PLANT: GE Nuclear Energy (GE)
 SUBJECT: Advanced Boiling Water Reactor (ABWR)
 SUBJECT: AUDIT SUMMARY - ADVANCED BOILING WATER REACTOR (ABWR) INSPECTIONS, TESTS, ANALYSES, AND ACCEPTANCE CRITERIA (ITAAC) ON REACTOR VESSEL INTERNALS

AUDIT SUMMARY - ABWR RPV AND INTERNALSOBJECTIVES:

NRC Audit of GE on
ABWR ITAAC OF REACTOR VESSEL AND INTERNALS

Figure 2.1.1 REACTOR PRESSURE VESSEL SYSTEM KEY FEATURES

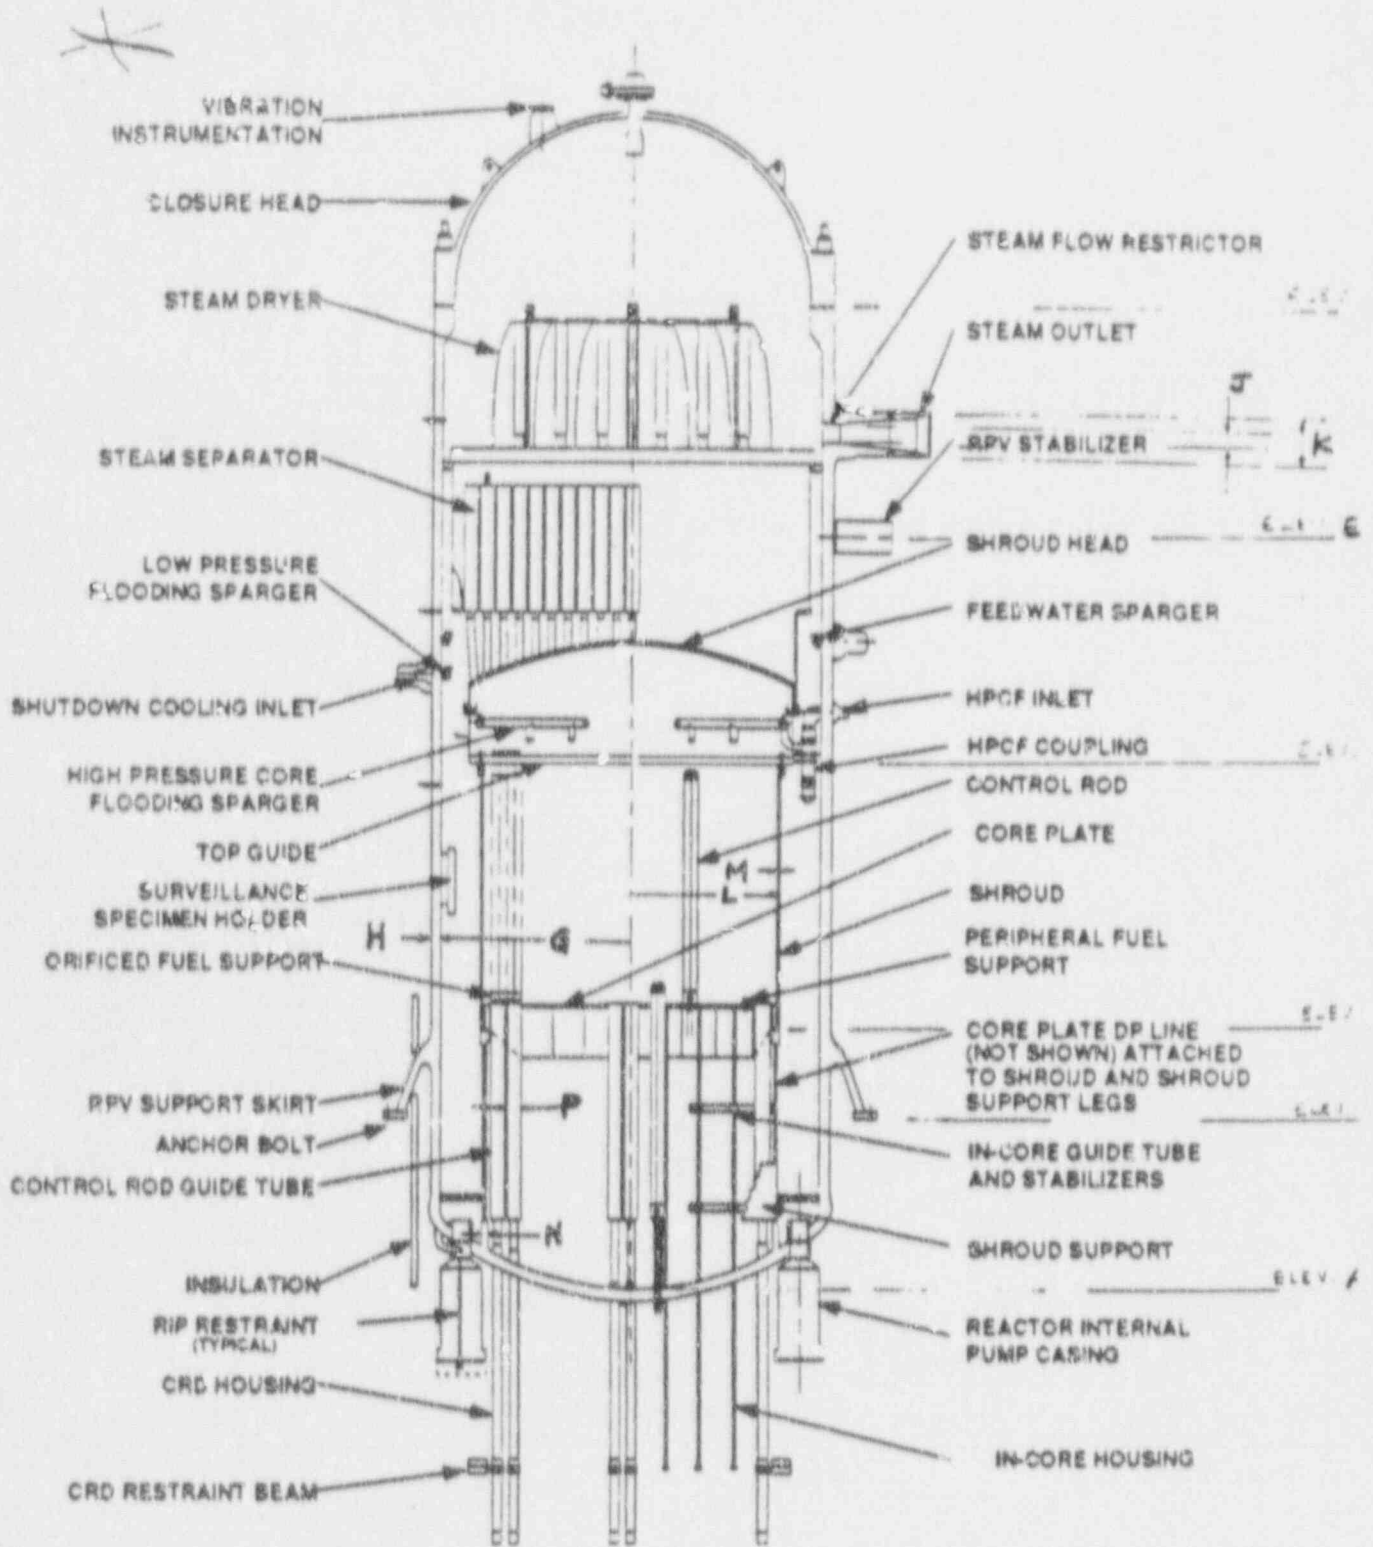
1. GE agreed that the pilot ITAAC related to the RPV system, as shown in Table 2.1.1 of the GE submittal dated January 17, 1992 will be revised as marked in Enclosure 3 to address the staff concerns.
2. As suggested by the staff, GE agreed to add new tables and figures (see Table 2.1.1-1, 2.1.1-2, 2.1.1-3 and Figure 2.1.1-2a, 2.1.1-2b in Enclosure 3) to the ITAAC, and revise the existing Figure 2.1.1-1. Thus, our concern on key dimensions and major design parameters of the RPV and internals is

resolved. However, construction tolerances of the listed key dimensions as shown in the column of "Variation" in Table 2.1.1-3 remain to be defined. GE indicated that values of variation will be proposed to the staff within two weeks.

Key dimensions and design details of RPVS components are presented in Table 2.1.1-1 and Figure 2.1.1-2, respectively. The major plant design parameters are listed in Table 2.1.1-3.

Description	Elev./Dim. (Figure 2.1.1-1)	Value (mm)
RPV ID	G	7061
RPV wall thickness in beltline	H	190.5
RPV bottom head inside invert	A	0.00
Top of RPV flange	F	17703.0
RPV skirt support bottom	B	3200.0
RPV Stabilizer connection	E	13766.0
Shroud OD	L	5550.0
Shroud wall thickness	M	50.8
Steam nozzle OD	K	7000
Steam nozzle flow element throat dia.	J	353.8
Core plate support	C	4695.2
Top guide support	D	9351.2
Shroud support legs (Fig. 2.1.1-2a)	N	153.0
Control rod guide tube OD	P	273.05

Description	Elev./Dim. (Figure 2.1.1-1)	Variation (mm)
RPV ID	G	 Remain to be defined 
RPV wall thickness in beltline	H	
RPV bottom head inside invert	A	
Top of RPV flange	F	
RPV skirt support bottom	B	
RPV Stabilizer connection	E	
Shroud OD	L	
Shroud wall thickness	M	
Steam nozzle OD	K	
Steam nozzle flow element throat dia.	J	
Core plate support	C	
Top guide support	D	
Shroud support legs (Fig. 2.1.1-2a)	N	
Control rod guide tube OD	P
